7 Greville Place
London NW6 5JP

Basement Impact Assessment
Audit

For
London Borough of Camden

Project Number: 12336-63
Revision: D2

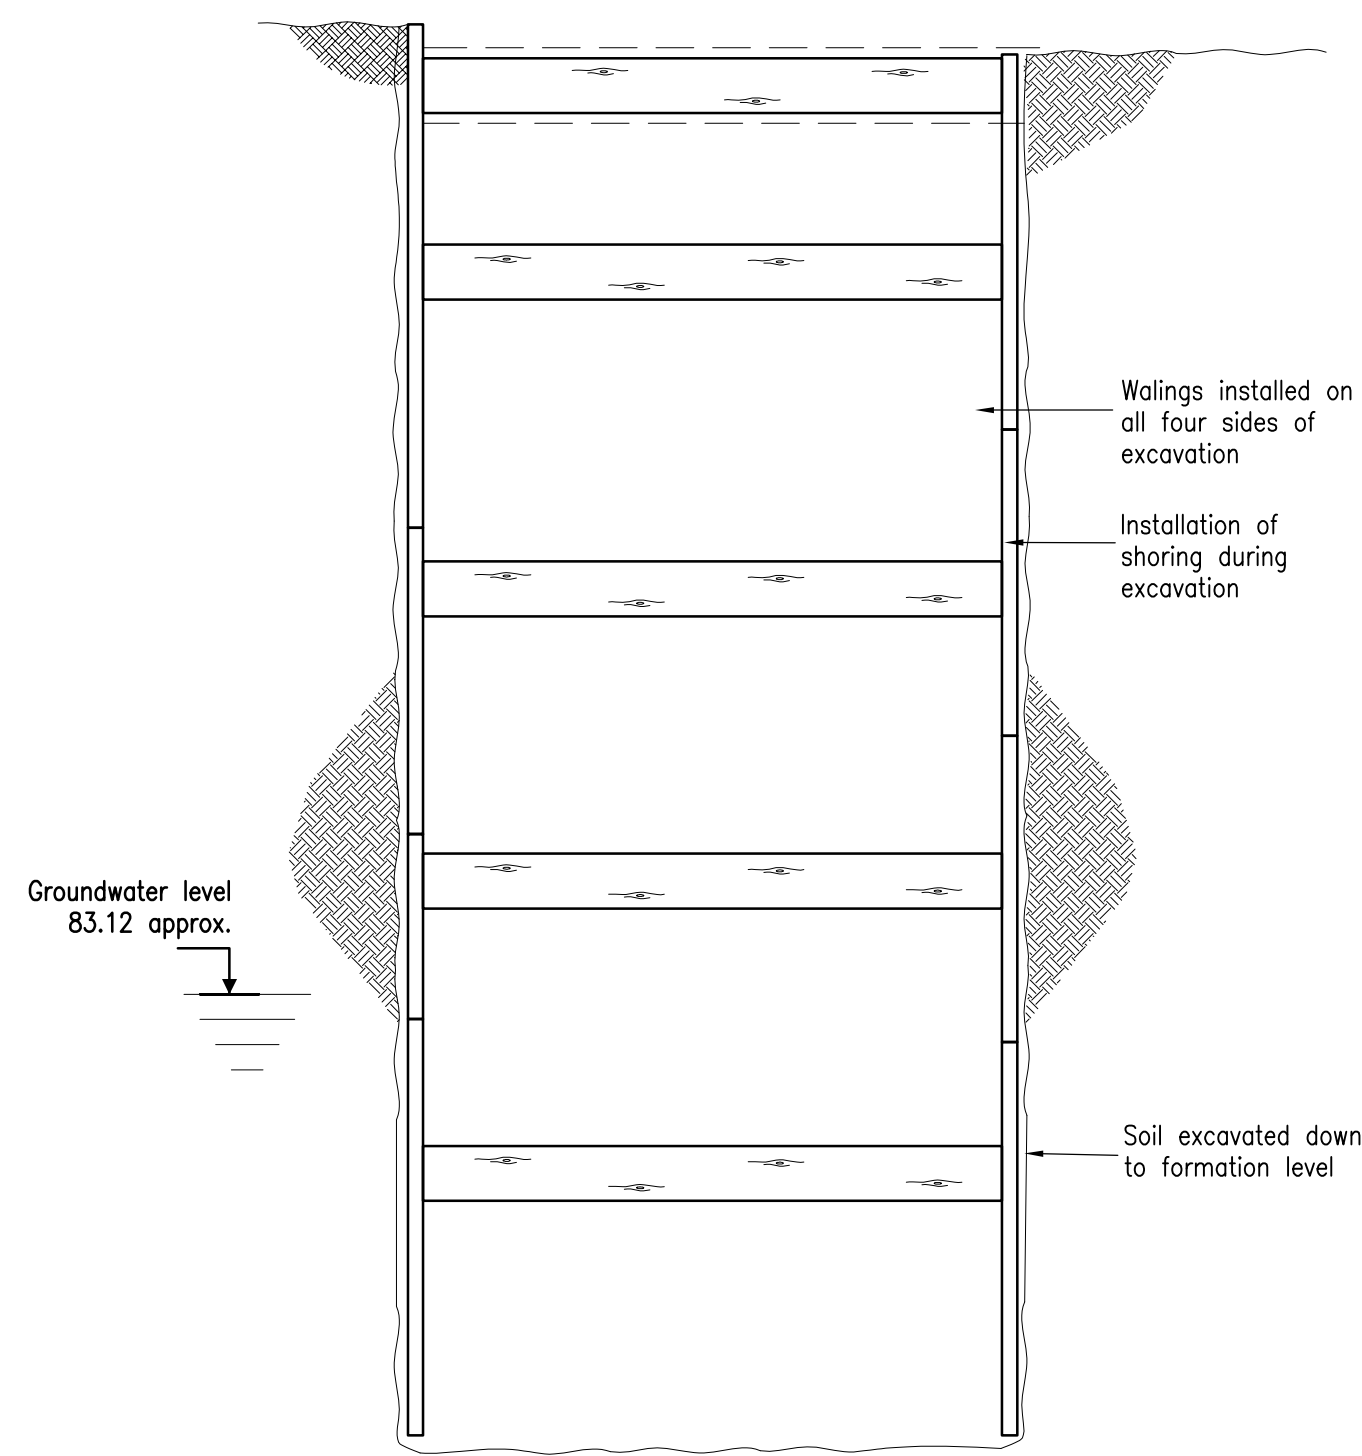
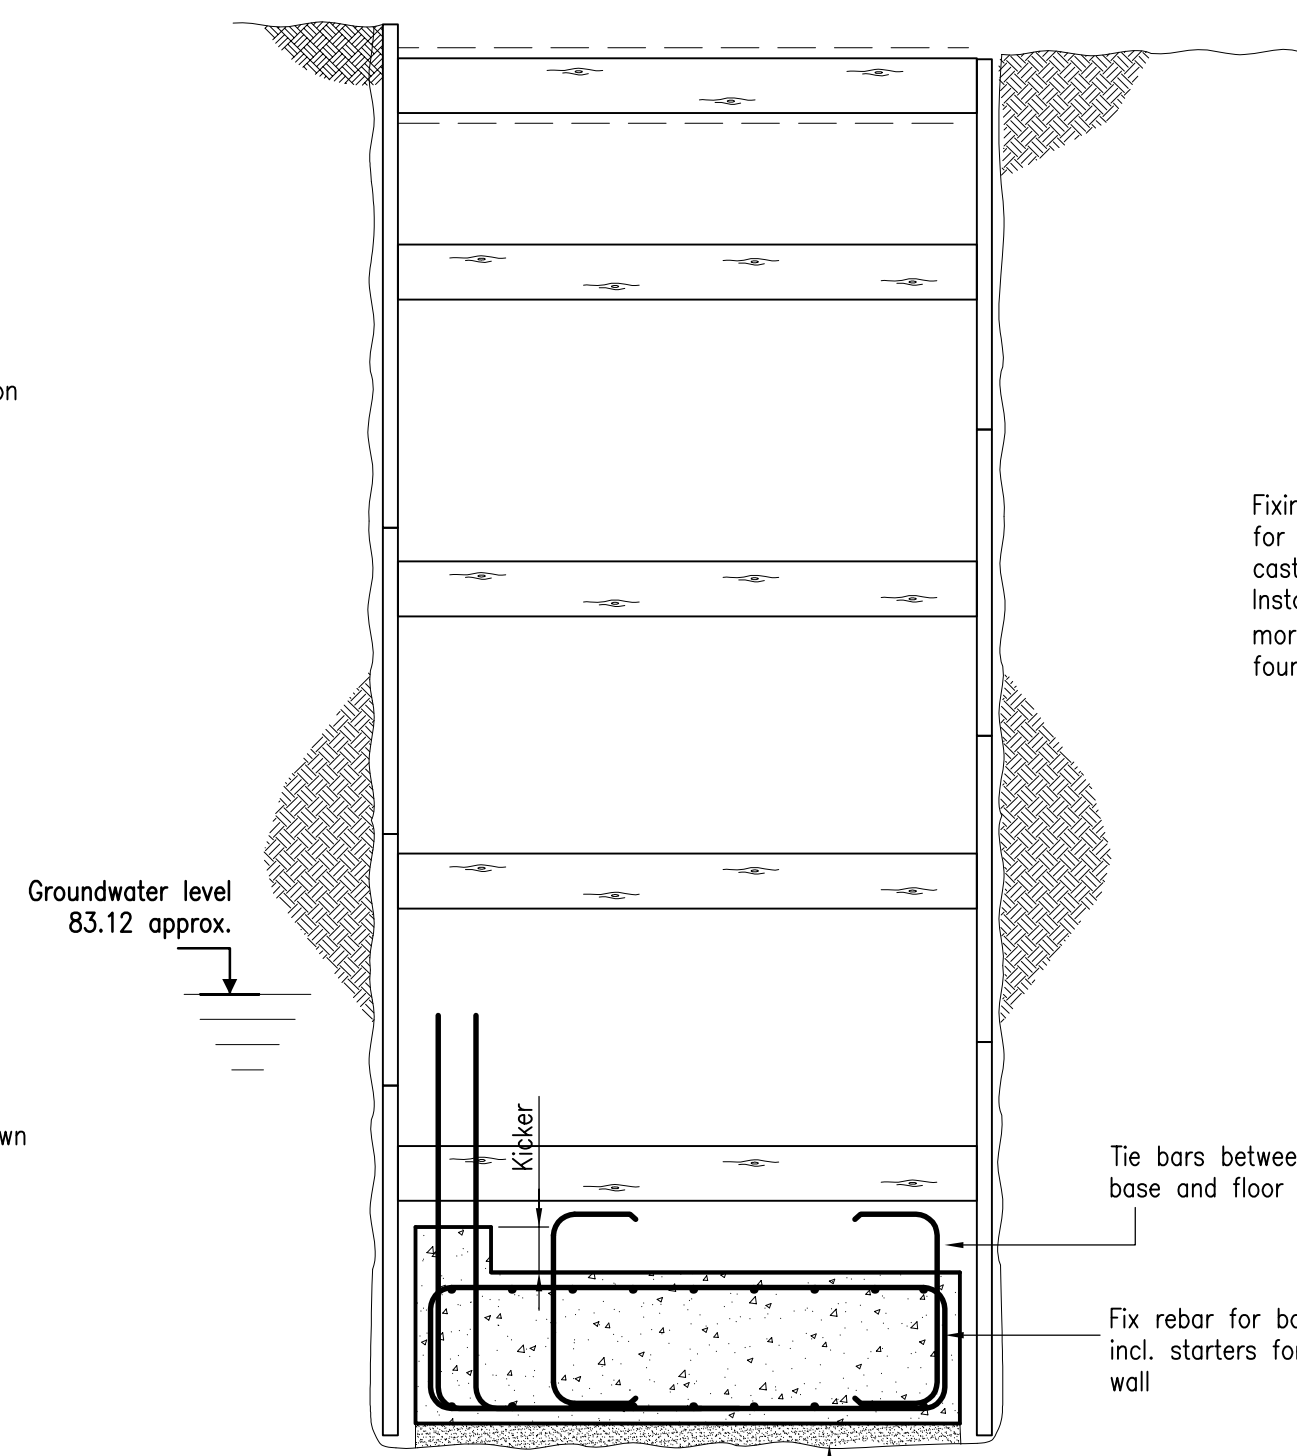
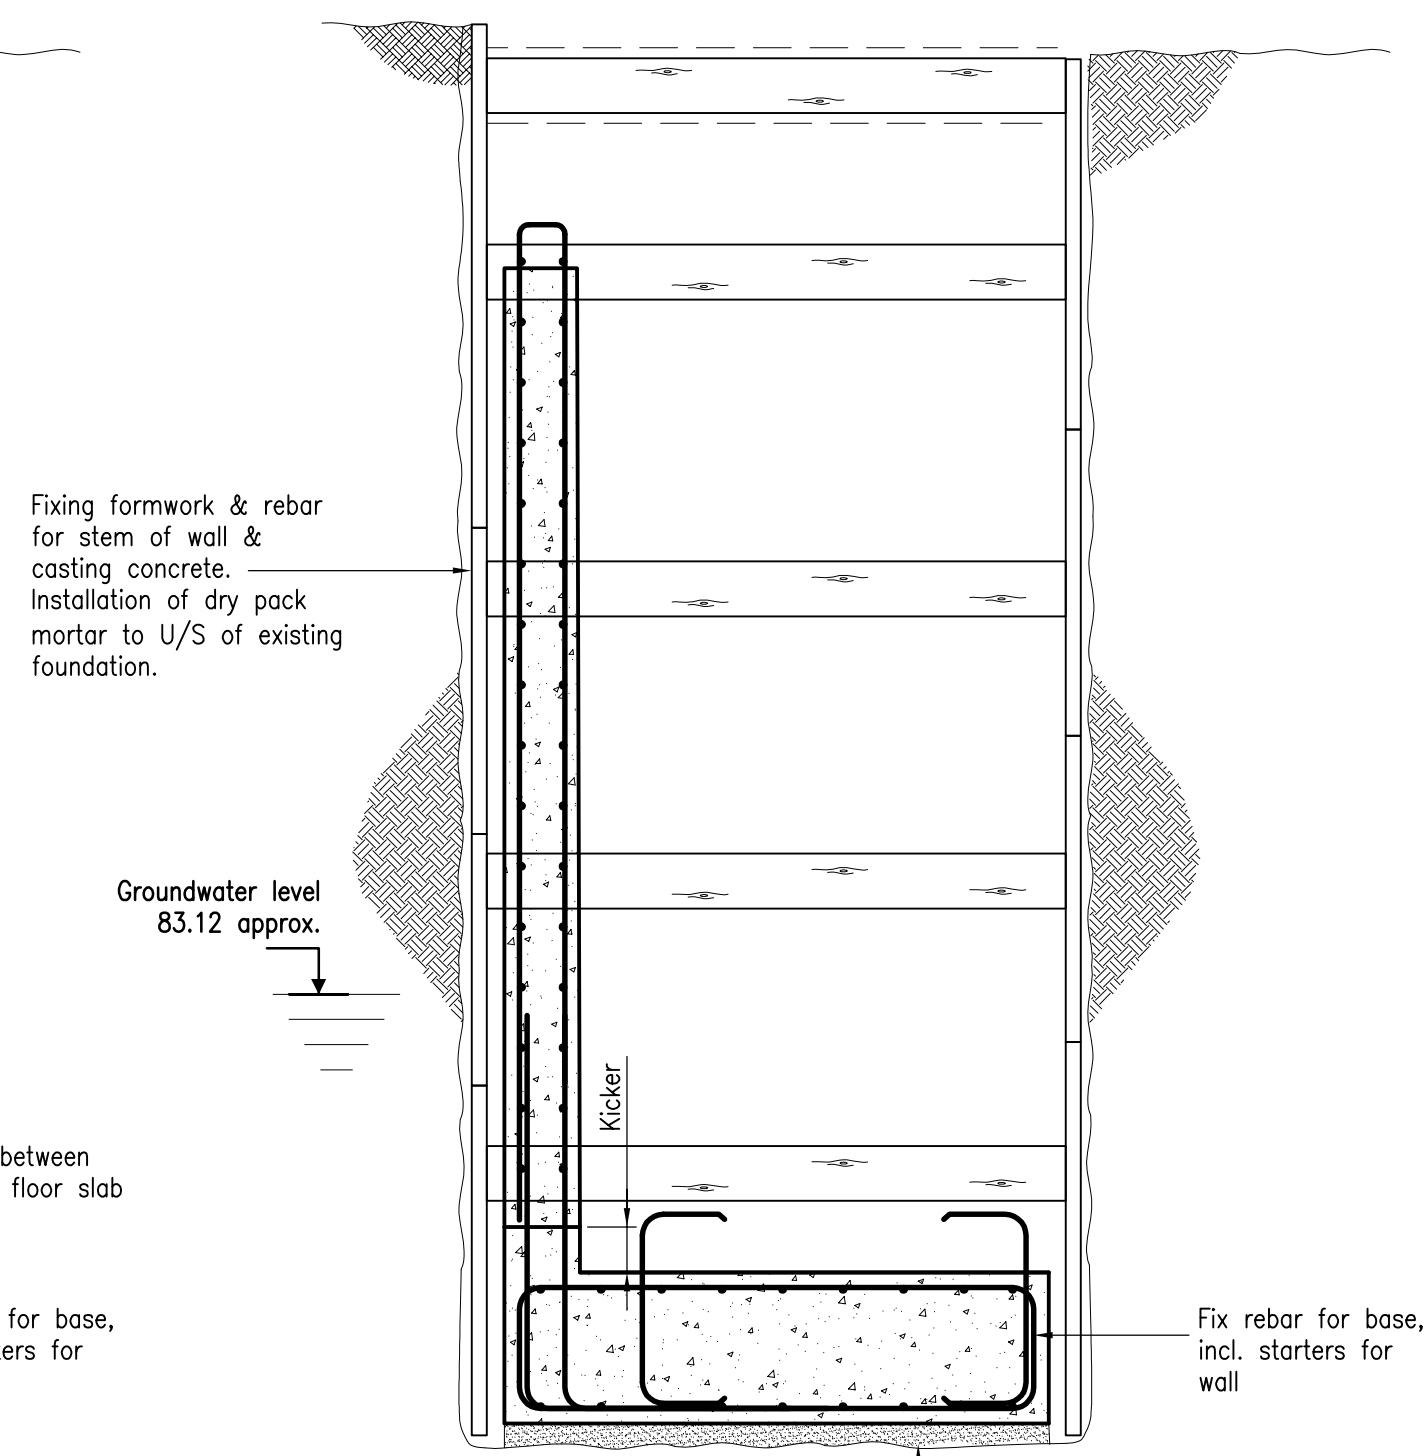
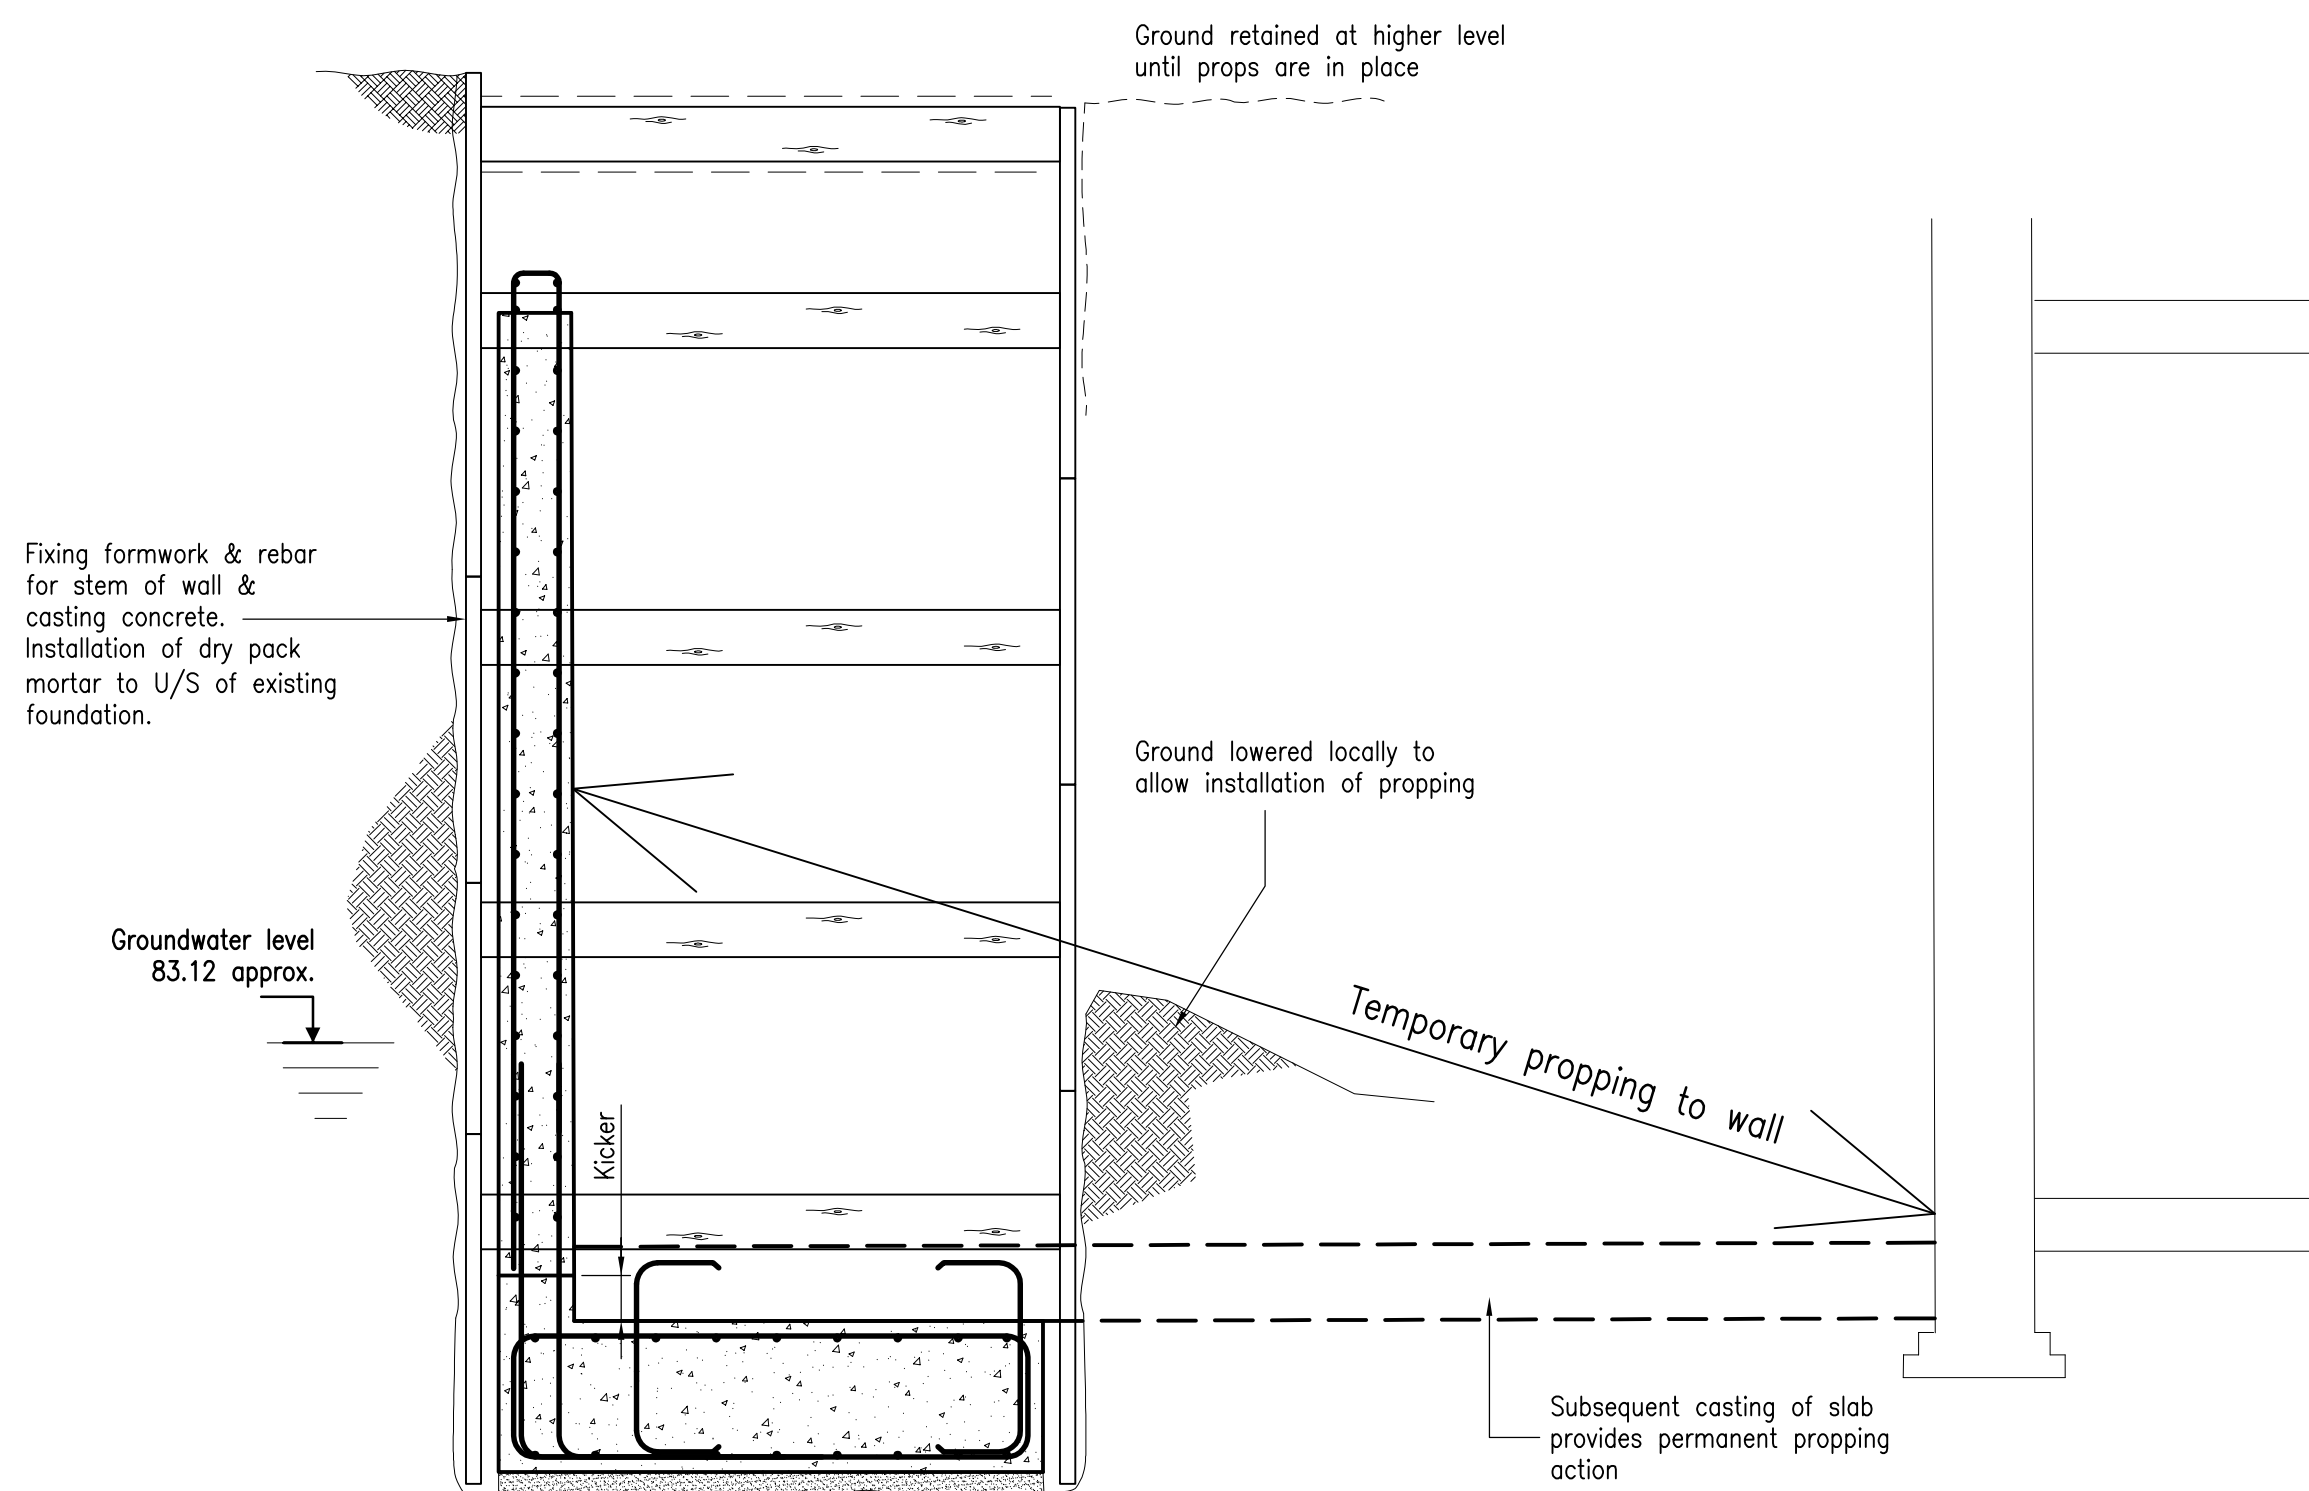
- 4.9. The proposed basement is to be formed by underpinning. It is stated that the construction of the walls of the new basement extension will involve “carrying out local excavations of around 1m in width and down to the formation level of the new basement”. A description of temporary works during construction and construction sequence was requested and has now been provided.

7	Stability	No estimates of ground movement and structural impact presented (see Audit paragraph 4.11)	Open- to be provided.	
8	Stability	No temporary works proposal provided	Closed- provided.	10.08.16
9	Stability	Damage category for neighbouring properties not provided (see Audit paragraph 4.12)	Open- Anticipated movements from all construction activities to be provided together with damage category for neighbouring properties.	
10	Stability	Movement monitoring proposal not provided (see Audit paragraph 4.14).	Open- Outline proposal to be provided. Details and trigger levels to be agreed as part of Party Wall awards.

8	Stability	No temporary works proposal provided (see Audit paragraph 4.4)	Open- to be provided	<p>The summary of geotechnical testing undertaken is provided in Table 13.2</p> <p>The accompanying Halstead Associates drawing 16497/PL03A shows the general sequencing for forming the perimeter retaining wall. Each section will be restrained and propped within its own excavation as shown until the base slab and ground floor slab are poured. The wall will be propped against the existing house while the infill soil is being removed.</p>
9	Stability	Damage category for neighbouring properties not provided. No consideration of impact on public highway	Open- Anticipated movements from all construction activities to be provided together with damage category for neighbouring properties. Impact on pathway to be considered.	<p>We do give recommendations on construction methodology to ensure that this is kept to a minimum, Section 14.3</p> <p>The excavation is set back from the rear edge of the public footway and fully propped at all times during the works as previously described. As a result no impact is expected on the public highway.</p>
